Access Compliance Report

Public Rights-of-Way

(Curb Ramps)

Intersection ID: 14360	Main Street: BALDWIN_AV	Cross Street: MAIN_ST	Location: W
ADA ID: 6856AFC4D6E0	Ramp Type: Perp	Initial Pass/Fail: Fail	Overall Compliance: No
Severity Score: 12.5			
Codes/Mitigation Info/Possible Solution		Field Measurements/Component Compliance

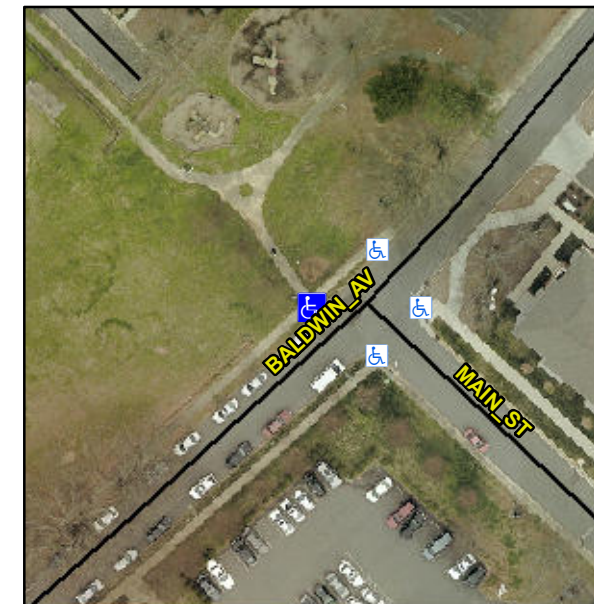
R304.5.3

Compliance	Description	Data	Compliance	Description	Data
N/A	Ramp Length (in)	100.0	Yes	Ramp Slope (%)	6.4
Yes	Ramp Width (in)	48.0	No	Ramp XSlope (%)	5.6
N/A	Flare Type LT	N/A	N/A	Flare Type RT	N/A
N/A	Flare Slope LT (%)	N/A	N/A	Flare Slope RT (%)	N/A
N/A	Flare Traversable LT?	N/A	N/A	Flare Traversable RT?	N/A
N/A	Landing Length (in)	N/A	N/A	DWS Provided?	N/A
N/A	Landing Width (in)	N/A	N/A	DWS Contrast?	N/A
N/A	Landing Slope (%)	N/A	N/A	DWS Length (in)	N/A
N/A	Landing X Slope (%)	N/A	N/A	DWS Full Width?	N/A
N/A	Landing Curb? (Y/N)	N/A	N/A	DWS Offset (in)	N/A
N/A	Shared Landing?	N/A			
N/A	Gutter Ponding?	N/A	N/A	Gutter Slope (%)	N/A
N/A	Gutter Lip Ht (in)	N/A	N/A	Gutter X Slope (%)	N/A
N/A	Painted X Walk1?	No	N/A	Painted X Walk2?	N/A
	X Walk 1 Direction	To SE		X Walk 2 Direction	N/A
N/A	X Walk 1 Width (in)	N/A	N/A	X Walk 2 Width (in)	N/A
	X Walk 1 Slope (%)	2.3		X Walk 2 Slope (%)	N/A
	X Walk 1 X Slope (%)	3.1		X Walk 2 X Slope (%)	N/A

Remove & Replace Entire Ramp.
